Access Compliance Report Public Rights-of-Way (Curb Ramps)

Main Street: N/A Cross Street: UNIVERSITY_DR Location: NW

ADA ID: RPRK211018110136 Ramp Type: Type 6 - Directional 1 Initial Pass/Fail: Pass Overall Compliance: No Severity Score: 10

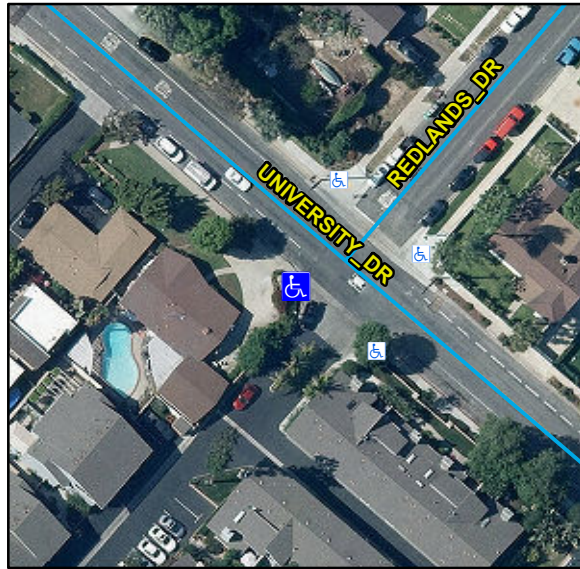
R304.2.1, R304.2.2-Perp, R304.3.2-Para, R304.5.3, STD 1115

Install Landing.
